Technical Service Bulletin

RUBBING/CONTACT MARKS ON CONVERTIBLE TOP (TOP FABRIC WITHOUT INNER CLOTH/HEADLINER)

Bulletin No.: 09-023/19

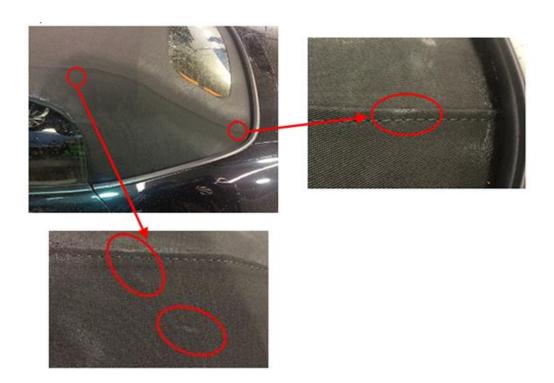
Some vehicles (without inner cloth/headliner) may exhibit rubbing/contact marks on the top fabric of the convertible top around the area as shown. The marks may occur on the right and/or left side(s). **NOTE:** Left side is shown.

This is caused by the top fabric receiving vibration and the stitching line (hard) touching the top fabric while the vehicle is running with the convertible top opened (top fabric folded and piled up). To correct this

concern, the link stopper of the convertible top has been changed to adjust the opening angle of the convertible top, thereby decreasing the contact pressure applied to the top fabric when folded and piled up.
